October 1, 2024

Reply to Attn of: **JQ: 204-15**

SUBJECT: Revised Hangar 1 Action Memorandum Amendment
MFA Leasehold
Mountain View, California

Areas of closeup photos
(see following pages)

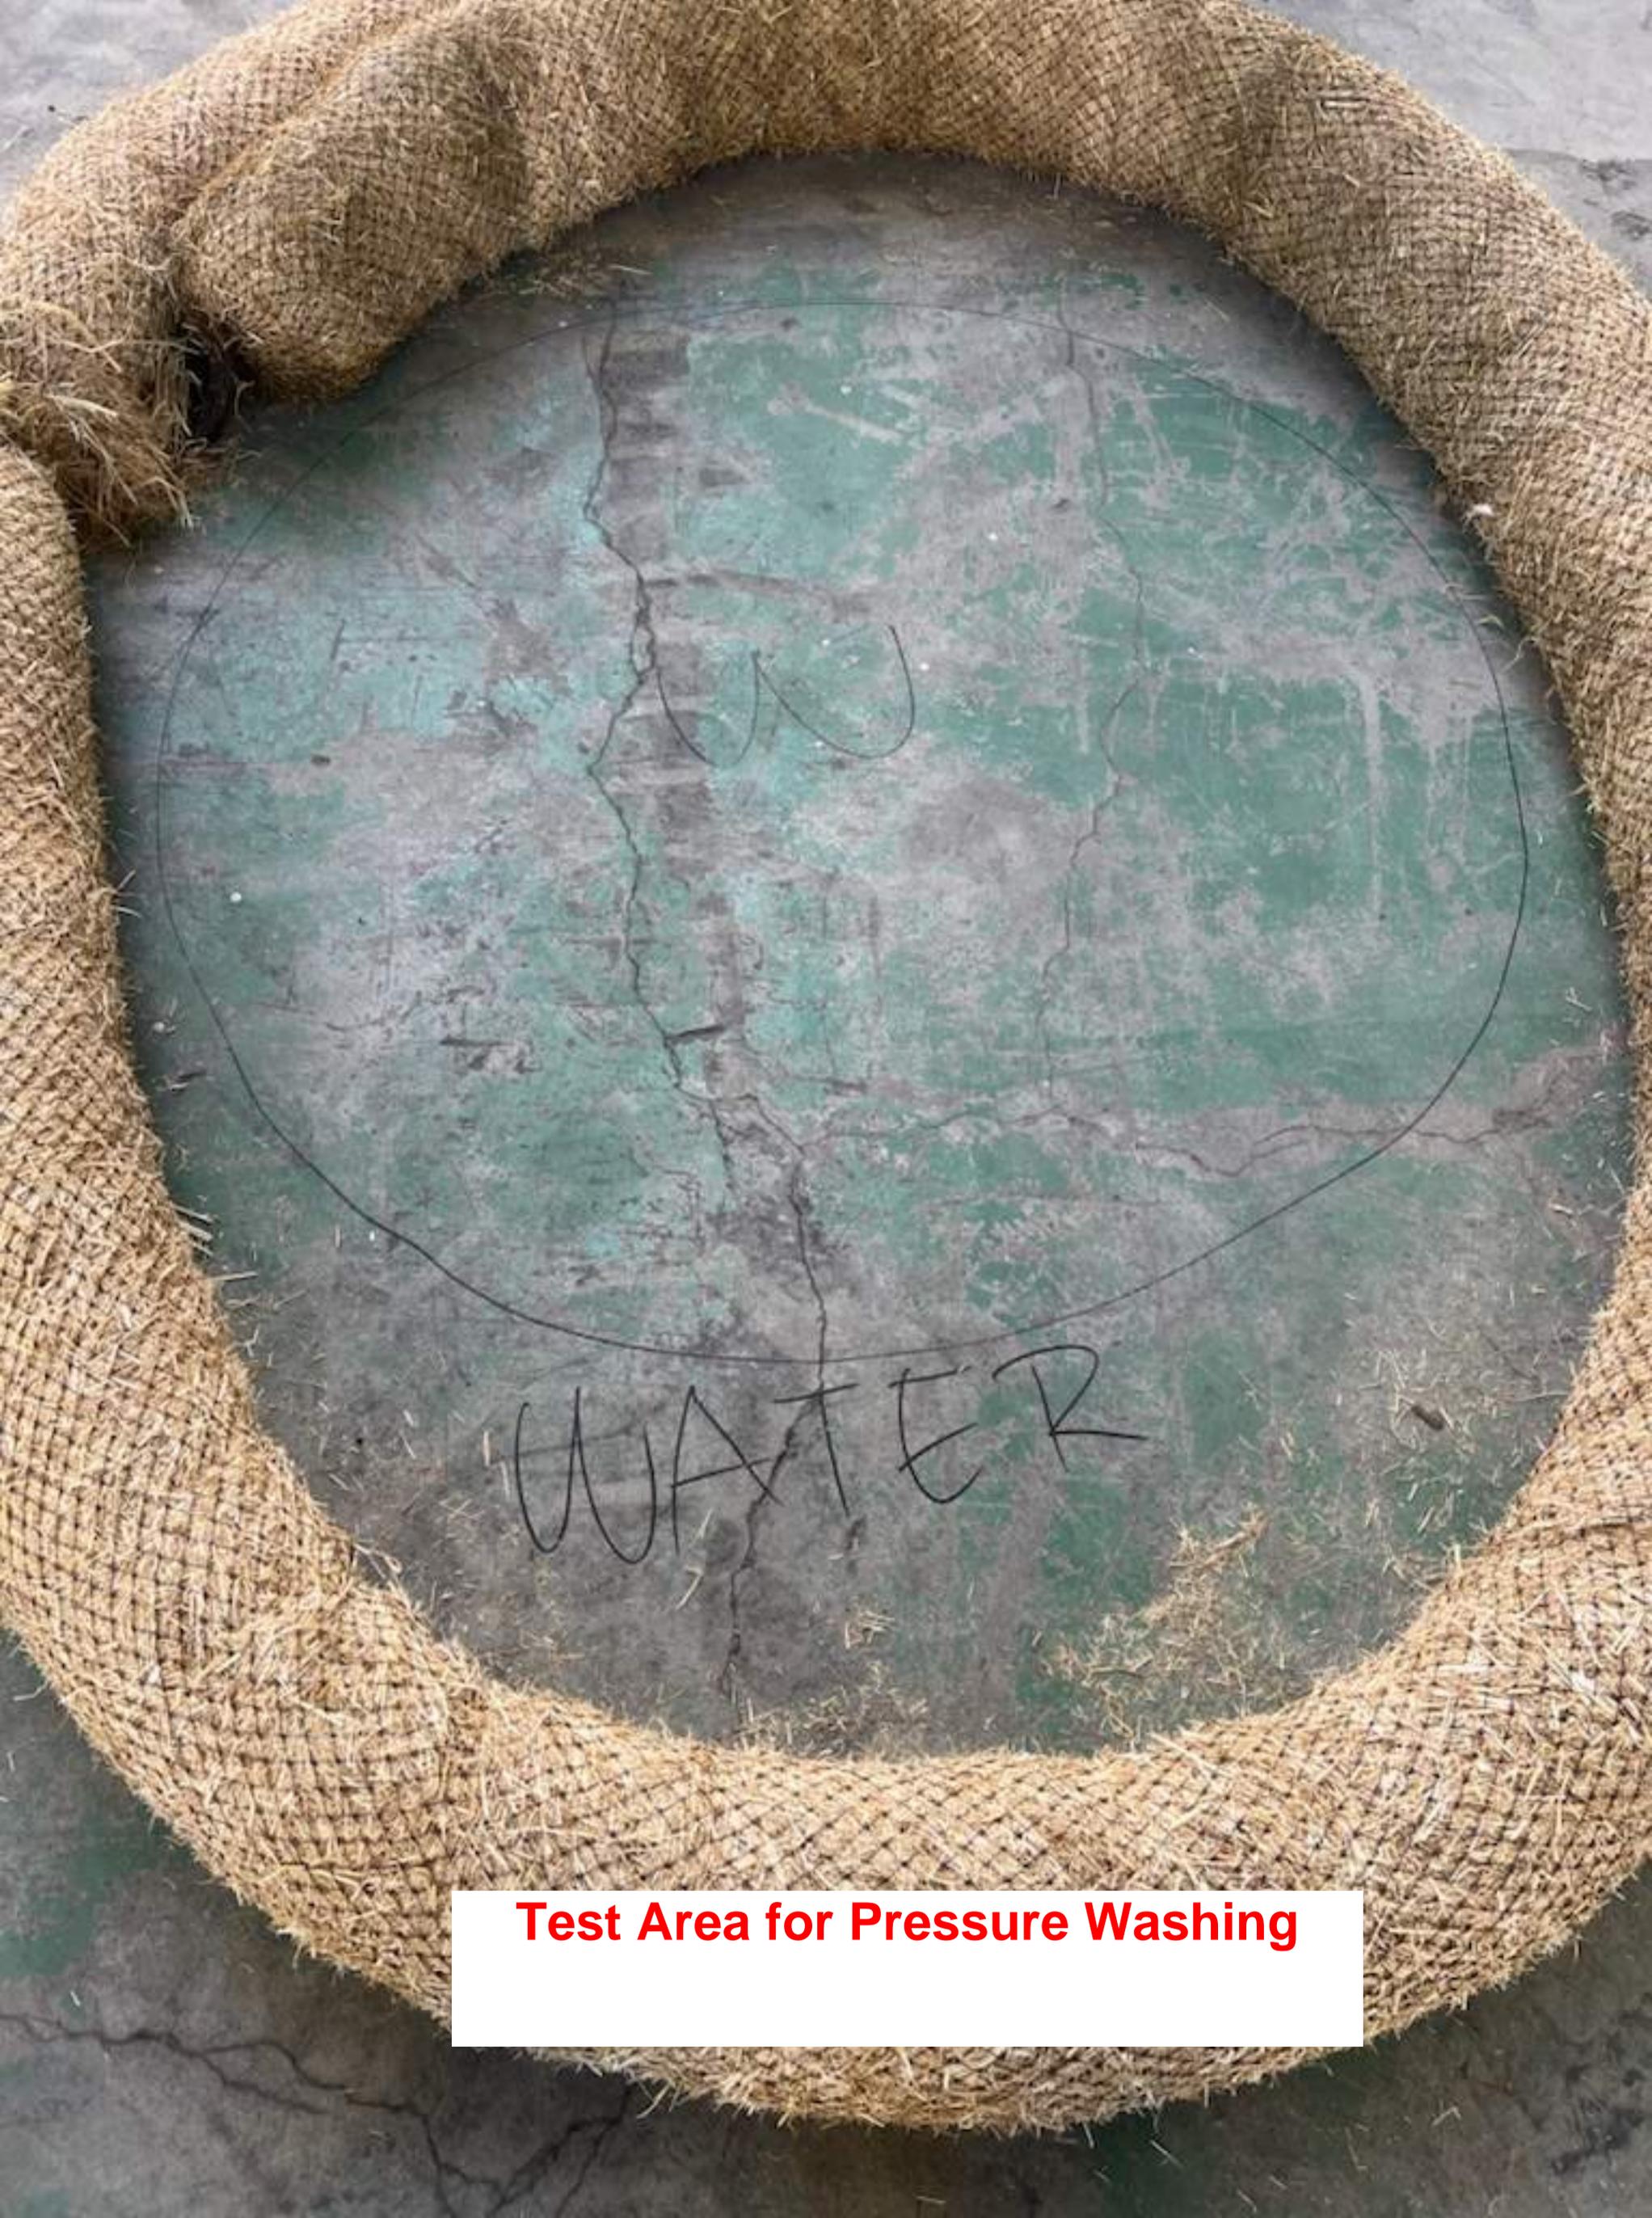
In April 2024, following the completion of all overhead work in Zone 2, the contractor performing the abatement activities began abating the painted concrete in Zone 2 in accordance with Section 5.1.6 of the NTCRA Work Plan (i.e., by chemical stripping and manual scraping). As seen in the photos in Attachment A, despite application of the chemical stripper and manual scraping, traces of paint are visible on the concrete floor. While the abatement contractor reapplied the chemical stripper to the same section of concrete floor several times, no additional paint could be removed by manual scraping and some paint remained visible. As can be seen in the closeup photos in Attachment A, the residual paint appears to be located in areas where the concrete floor appears to be rougher (i.e., areas where the original smoother finish has been degraded).

As the ability of manual scraping to access residual paint on the concrete floor is limited by the size of the scraper, the contractor also attempted to remove paint from the concrete floor by pressure washing. As seen in the photos in Attachment A, while pressure washing was able to remove the existing paint without damaging the concrete floor, residual paint still remained and overall, pressure washing was less effective than chemical stripping combined with manual scraping.

Concrete is not a uniform surface¹ and contains pores², thus it is not possible to achieve the visual Cleanup Goal of “no visible paint remains” using chemical stripping and manual scraping because manual scraping cannot remove paint that has accumulated in the valleys and/or pore spaces of the concrete. While achieving the visual Cleanup Goal might be possible using more aggressive techniques such as media blasting (which would likely wear down the surface of the concrete), the use of such techniques would damage the historic fabric of Hangar 1³. As a result, the use of such techniques would have to be approved by the State Historic

NASA intends to revise the visual Cleanup Goal for porous surfaces from “No visible paint remains” to “All paint removed to the extent practicable without damaging the historic fabric of the concrete floor” because the chemical stripping and manual scraping procedure is not capable of meeting the visual Cleanup Goal. This revised Cleanup Goal is appropriate because (1) the chemical stripping and manual scraping procedure meets the RAO of the AM and (2) the confirmation sampling data from the test areas indicates that the bulk concentrations of PCBs and lead in the abated concrete floor are below the numeric Cleanup Goals and below unrestricted use levels. Consistent with the visual Cleanup Goal for non-porous surfaces, a
